To: Sam Hubbard, Development Planner, Planning and Community Development
From: Deb Pierce, Plan Reviewer, Building & Life Safety Department
Subject: 1100, 1400 W Dundee Rd., and 1510-1530 W Dundee Rd – Ridgeline Distribution Center
PC#: 21-009 – Round 2
Date: May 25, 2021

PLAN COMMISSION PC #21-009
Ridgeline Distribution Center
1100, 1400 W. Dundee Rd. and 1500-1530 W. Dundee Rd
Round 2

Project: Ridgeline/Rohrman Redevelopment

Case Number: PC 21-009

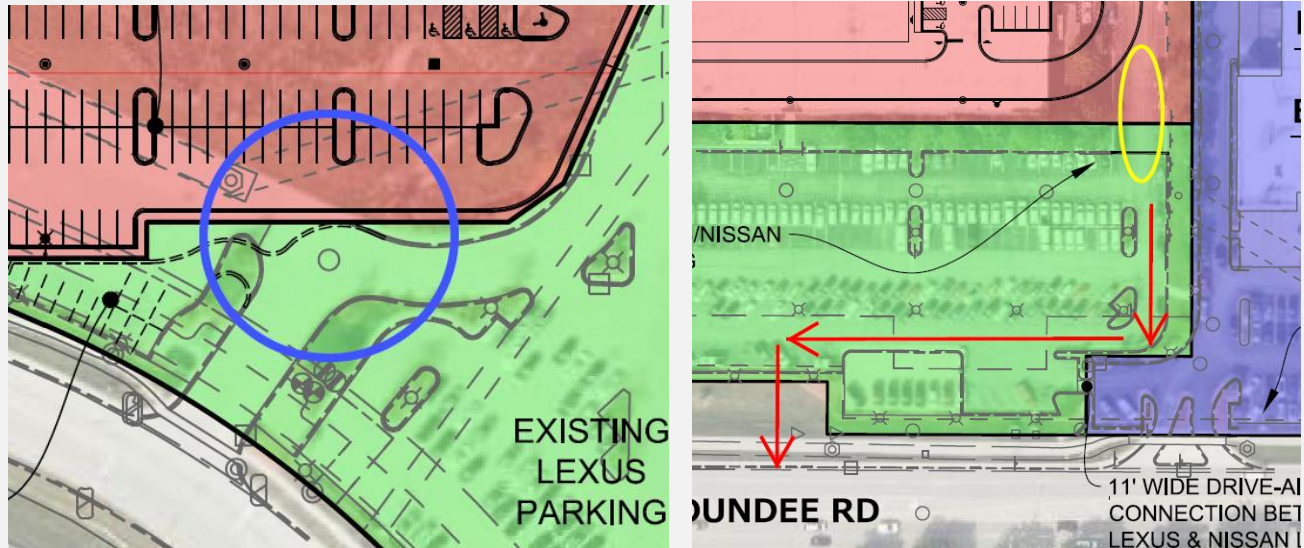
- 55) The response to comment #33 is not acceptable. Staff continues to recommend that passenger vehicle cross access be provided in the location as shown in blue below, which would provide passenger vehicle access at a signalized intersection to the Ridgeline property for safer vehicle movements. Staff continues to recommend a streamlined point of access between the Ridgeline lot and Lexus lot in the location as shown in yellow below, with future cross access to a potential signal as shown in red below. A connection and cross access easement between the Lexus site and the Nissan site should also be provided.
